## PIC10F220/222 Rev. A Silicon Errata

The PIC10F220/222 parts you have received conform functionally to the Device Data Sheet (DS41270B), except for the anomalies described below.

### 1. Module: Analog-to-Digital (A/D) Converter

FIGURE 1: TYPICAL DNL AT 2.0V (TESTING AT 7-BIT LEVEL)

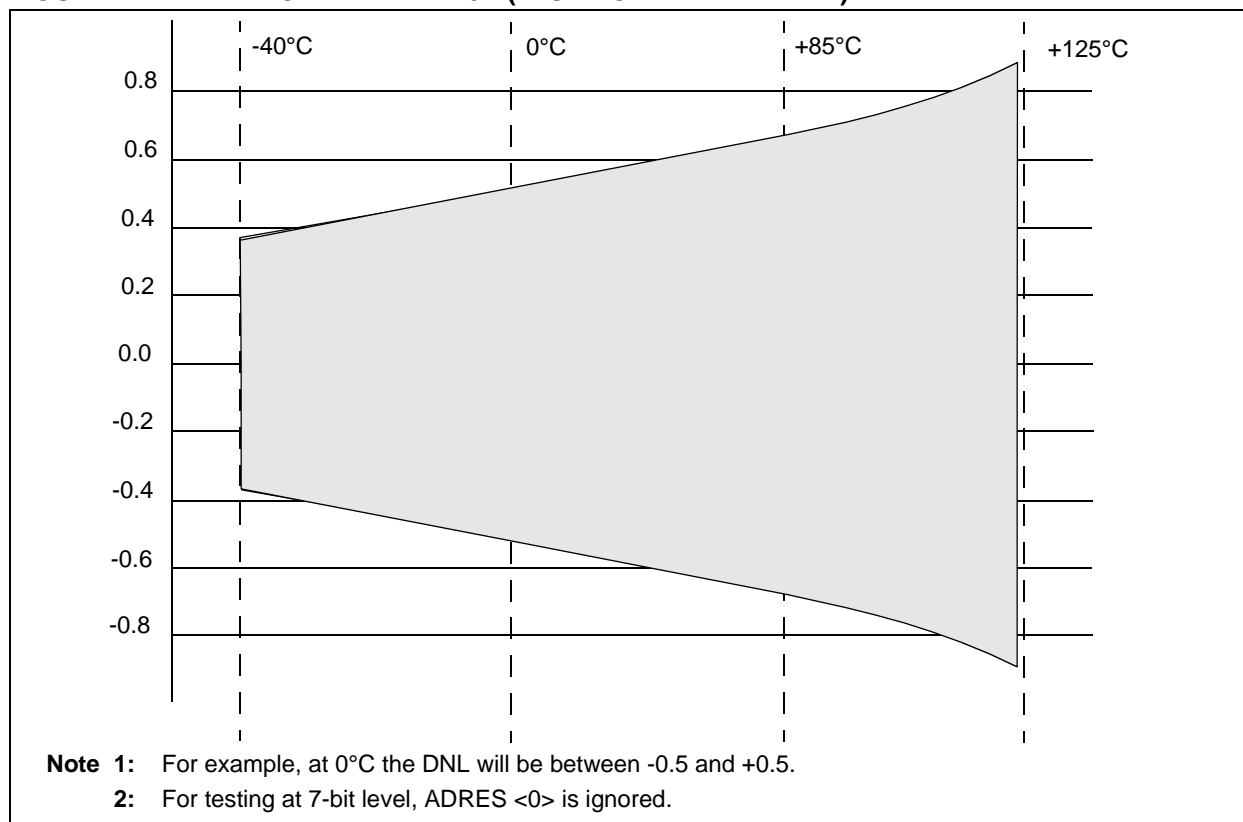
PIC10F220/222 silicon Rev. A1. The A/D Converter does not meet the design target. The specifications listed below in Table 10-6 supersede Table 10-6 in DS41270B.

**Work around:**

None.
